The Commission has issued the enclosed Amendment No. 8, Technical Specification Change No. 18 for License No. DPR-38; Amendment No. 8, Technical Specification Change No. 13 for License No. DPR-47; and Amendment No. 5, Technical Specification Change No. 5 for License No. DPR-55, for the Oconee Nuclear Station, Units 1, 2, and 3. These amendments are in response to your request dated May 9, 1975.

OCONEE NUCLEAR STATION, UNIT 3

ATTACHMENT TO LICENSE AMENDMENTS

SAFETY EVALUATION BY THE OFFICE OF NUCLEAR REACTOR REGULATION

UNIT 2
OCONEE NUCLEAR STATION
Figure 3.5.2-1B1

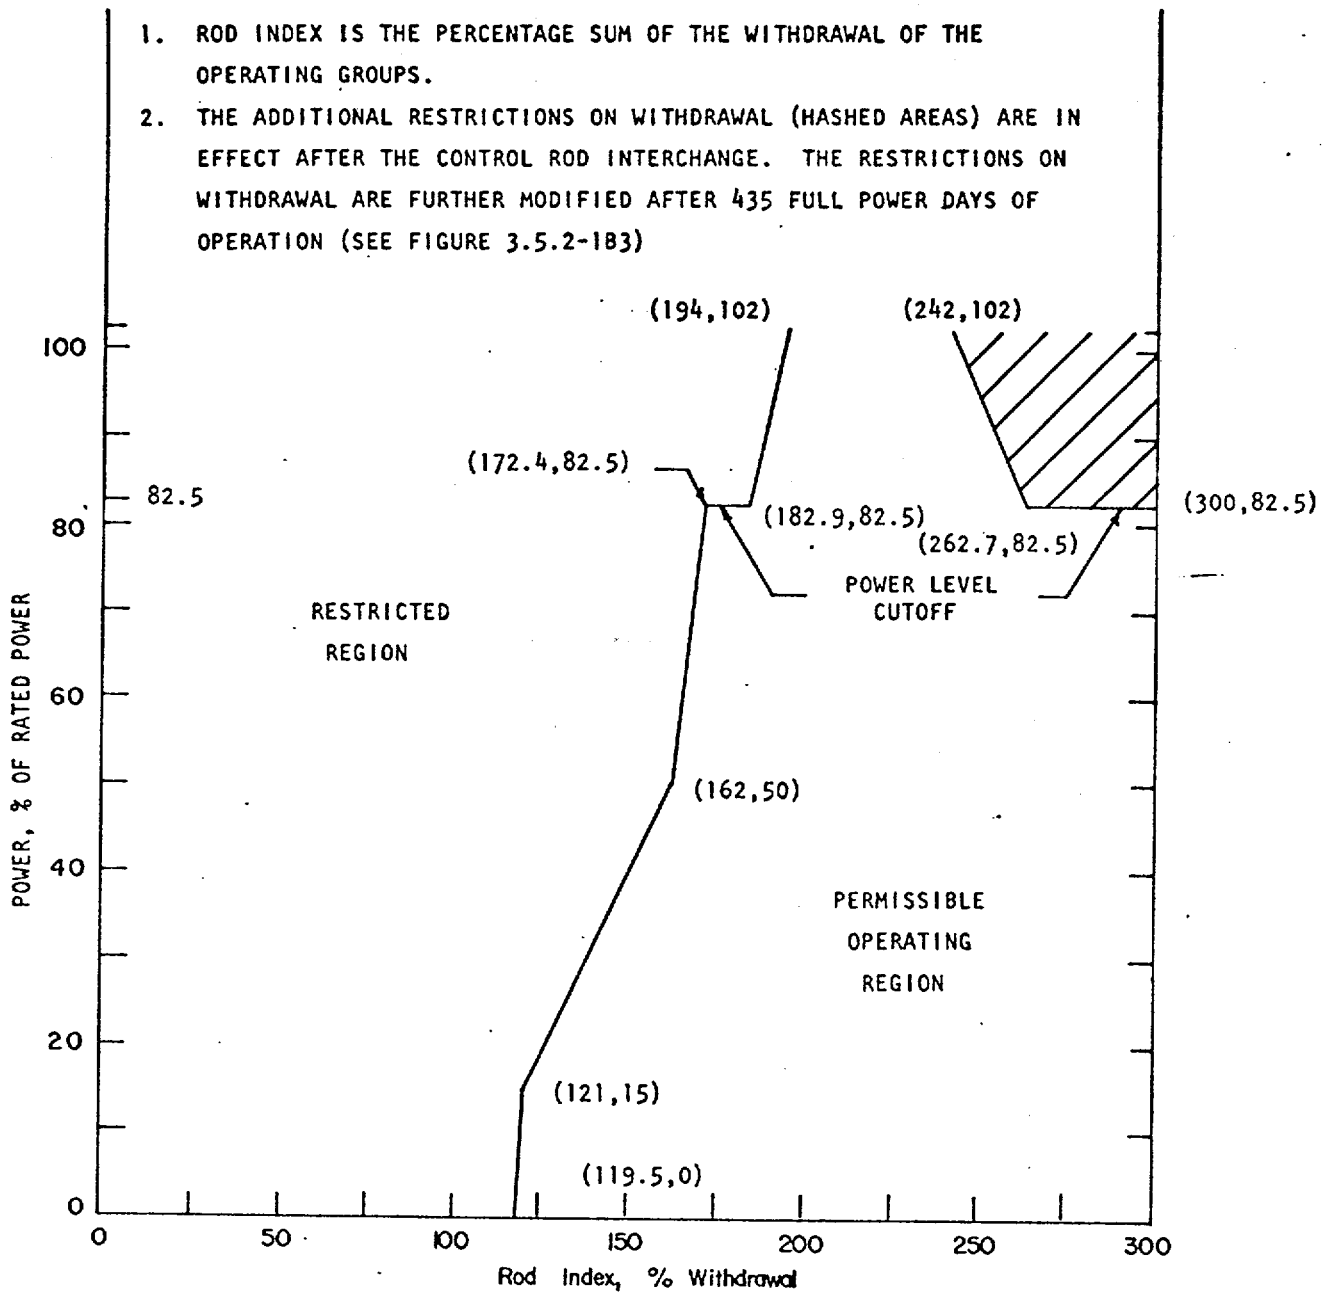
2. RESTRICTIONS ON WITHDRAWAL (HASHED AREAS) ARE MODIFIED AFTER THE CONTROL ROD INTERCHANGE (SEE FIGURE 3.5.2-1B2)

UNIT 2
OCONEE NUCLEAR STATION
Figure 3.5.2-1B2

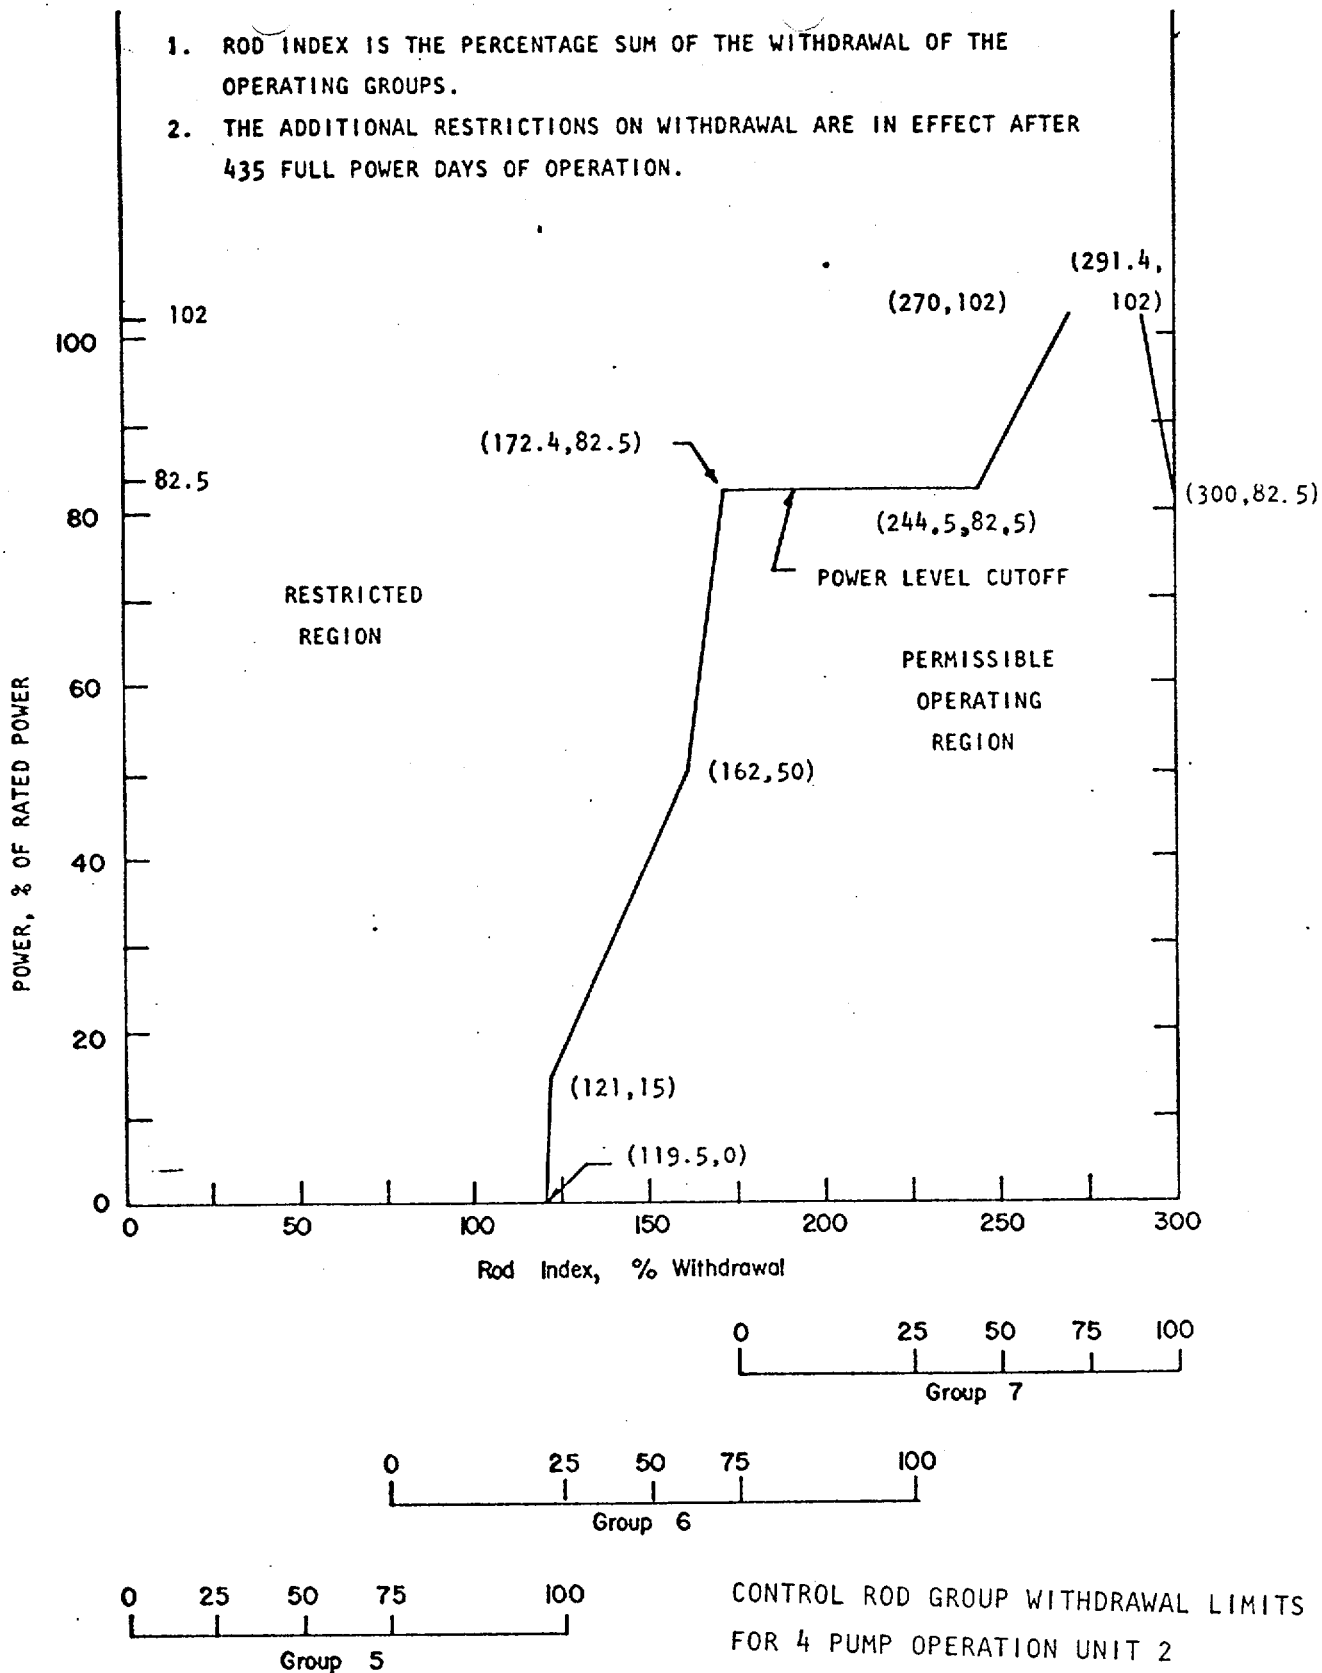
1. ROD INDEX IS THE PERCENTAGE SUM OF THE WITHDRAWAL OF THE OPERATING GROUPS.
2. THE ADDITIONAL RESTRICTIONS ON WITHDRAWAL (HASHED AREAS) ARE IN EFFECT AFTER THE CONTROL ROD INTERCHANGE. THE RESTRICTIONS ON WITHDRAWAL ARE FURTHER MODIFIED AFTER 435 FULL POWER DAYS OF OPERATION (SEE FIGURE 3.5.2-1B3)

UNIT 2
 OCONEE NUCLEAR STATION
 Figure 3.5.2-1B3

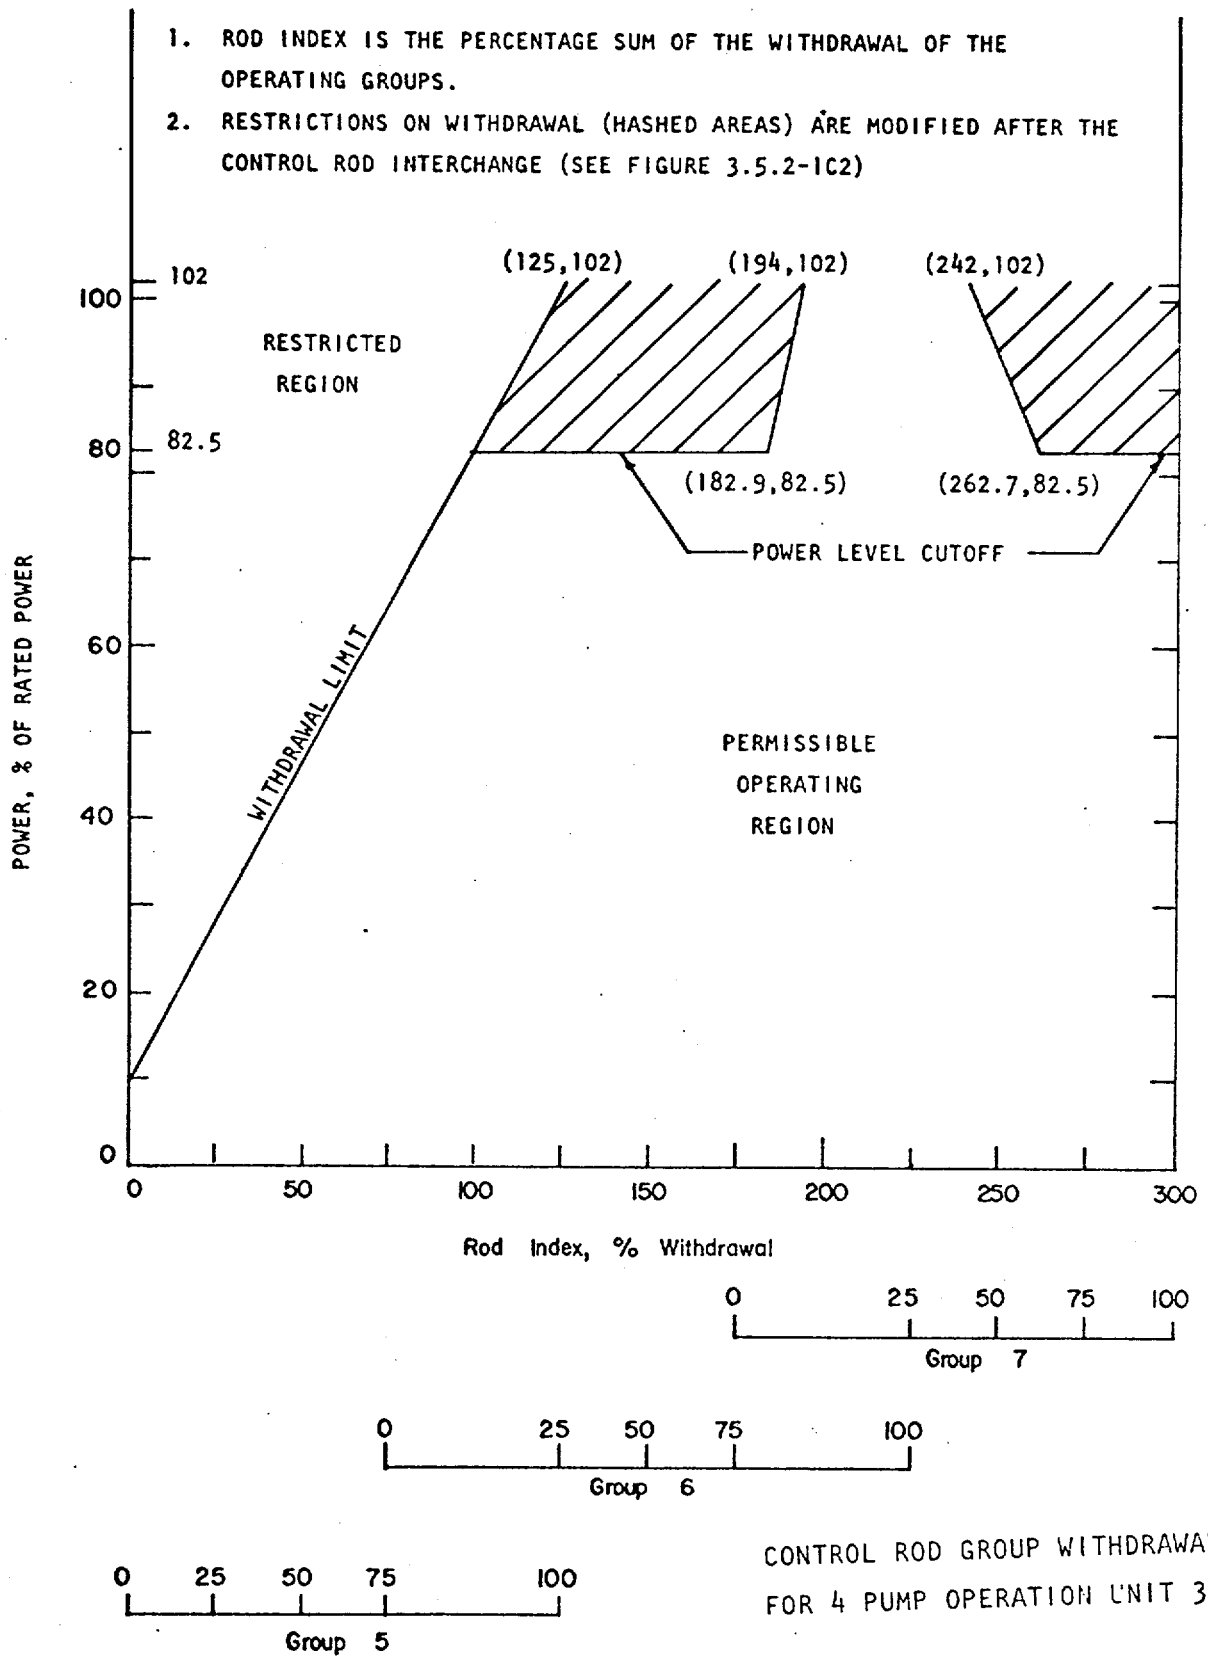
1. ROD INDEX IS THE PERCENTAGE SUM OF THE WITHDRAWAL OF THE OPERATING GROUPS.
2. THE ADDITIONAL RESTRICTIONS ON WITHDRAWAL ARE IN EFFECT AFTER 435 FULL POWER DAYS OF OPERATION.

UNIT 3
OCONEE NUCLEAR STATION
Figure 3.5.2-1C1

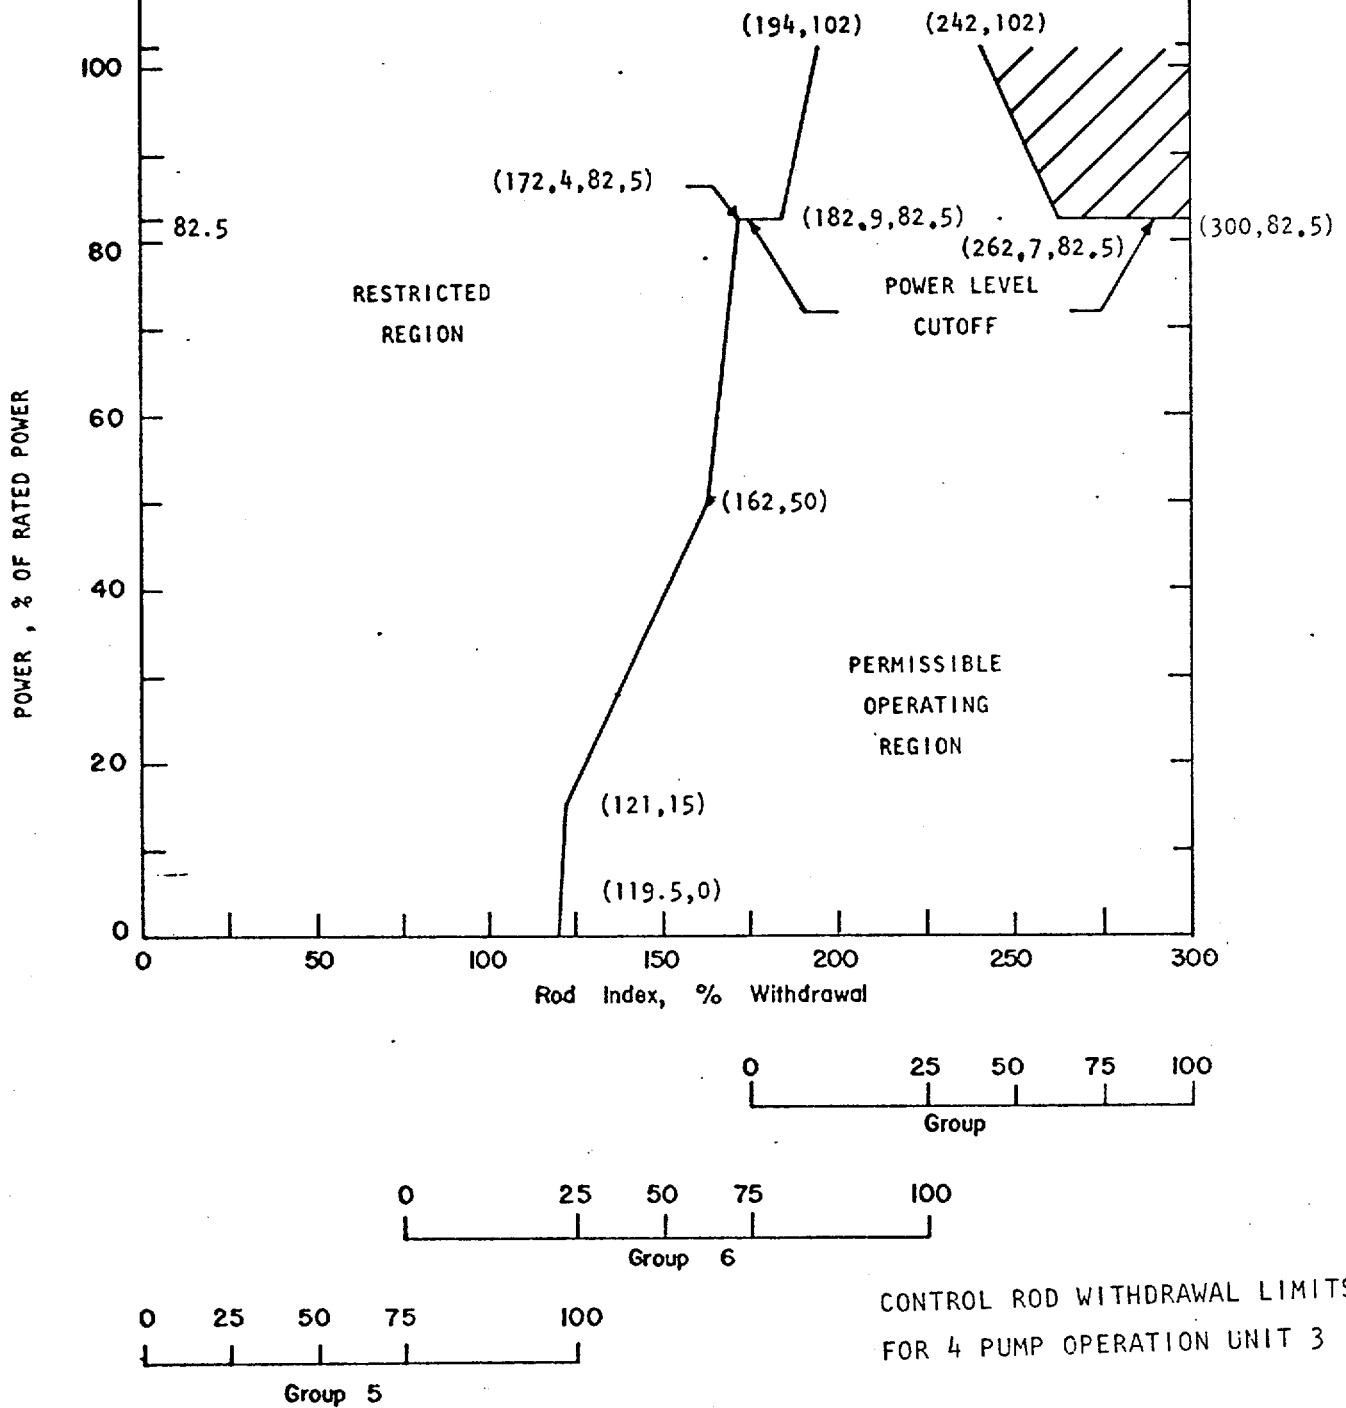
1. ROD INDEX IS THE PERCENTAGE SUM OF THE WITHDRAWAL OF THE OPERATING GROUPS.
2. RESTRICTIONS ON WITHDRAWAL (HASHED AREAS) ARE MODIFIED AFTER THE CONTROL ROD INTERCHANGE (SEE FIGURE 3.5.2-1C2)

UNIT 3
OCONEE NUCLEAR STATION
Figure 3.5.2-1C2

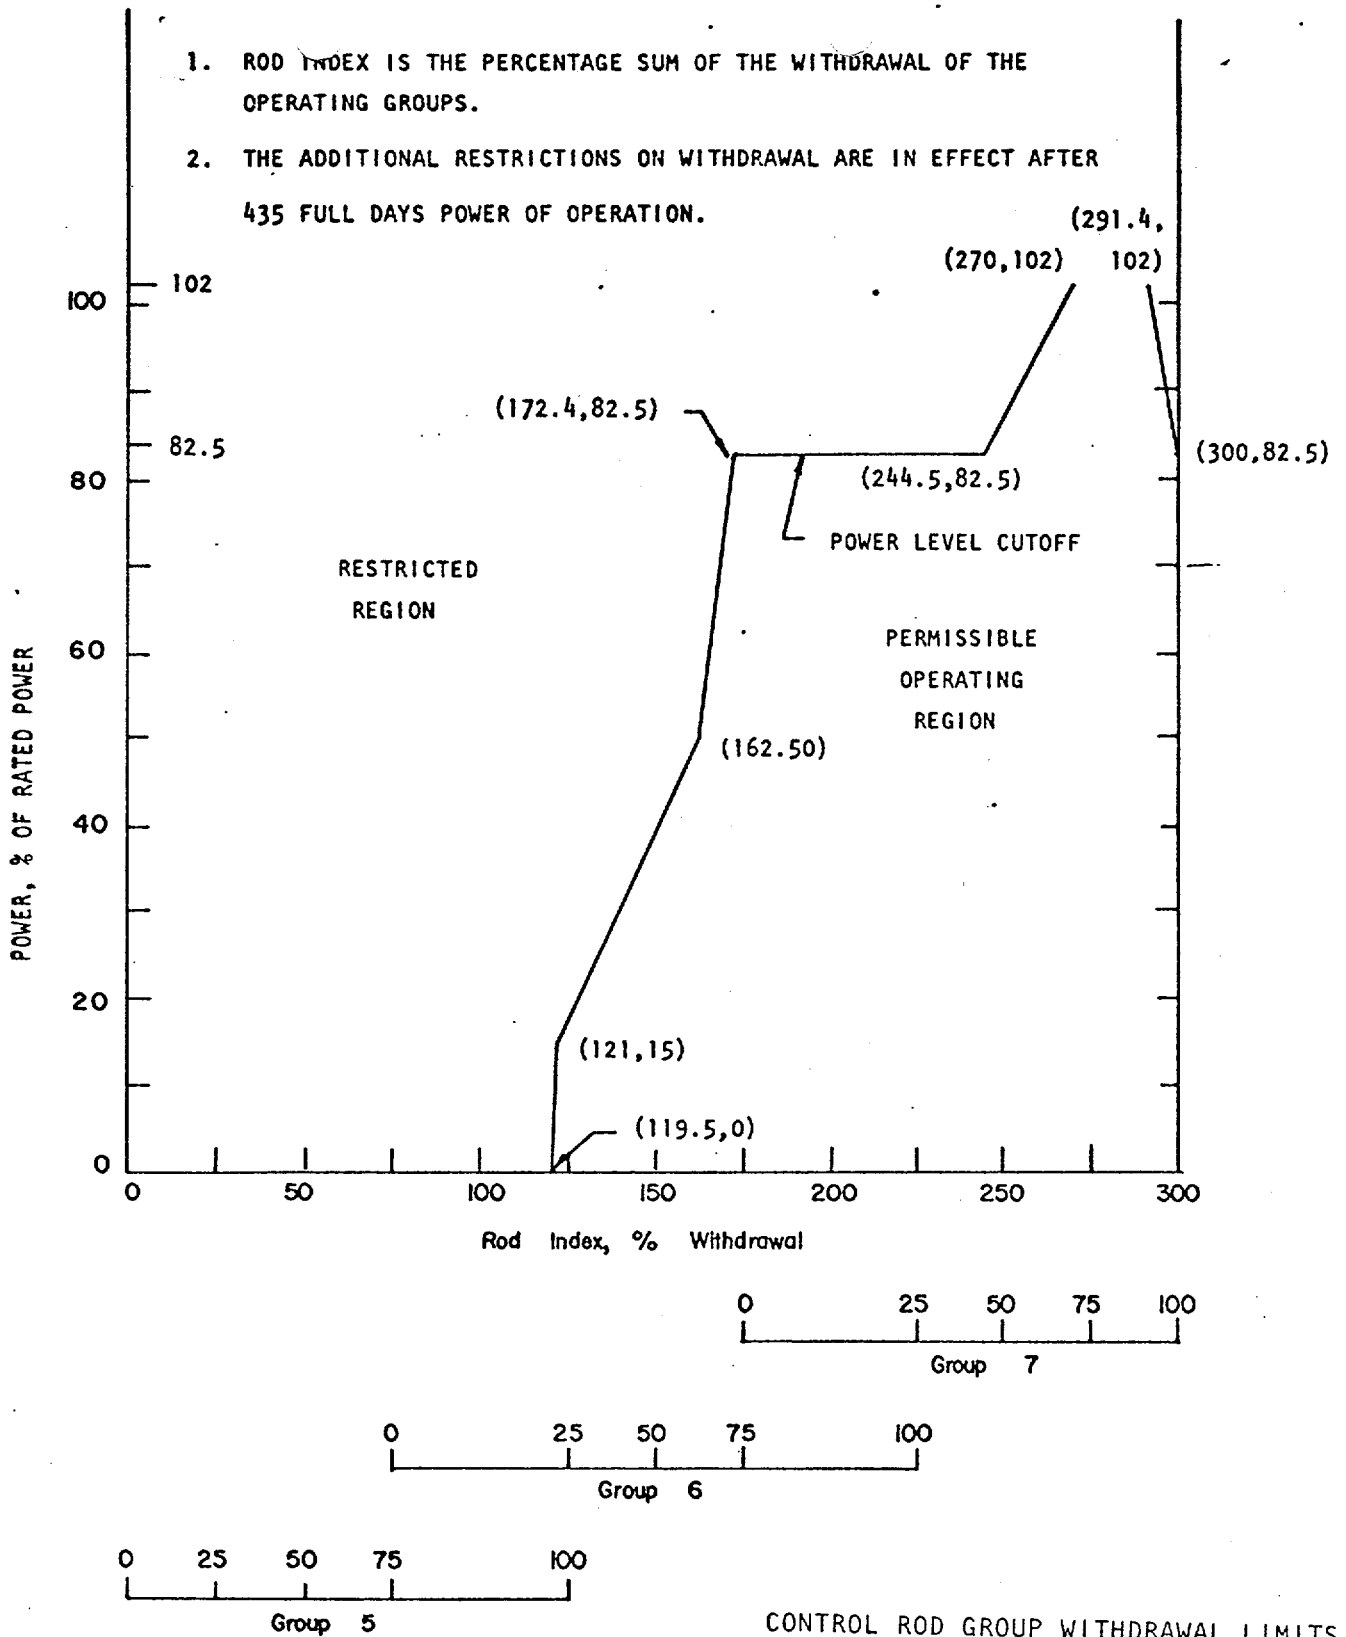
1. ROD INDEX IS THE PERCENTAGE SUM OF THE WITHDRAWAL OF THE OPERATING GROUPS.
2. THE ADDITIONAL RESTRICTIONS ON WITHDRAWAL (HASHED AREAS) ARE IN EFFECT AFTER THE CONTROL ROD INTERCHANGE. THE RESTRICTIONS ON WITHDRAWAL ARE FURTHER MODIFIED AFTER 435 FULL POWER DAYS OF OPERATION (SEE FIGURE 3.5.2-1C3)
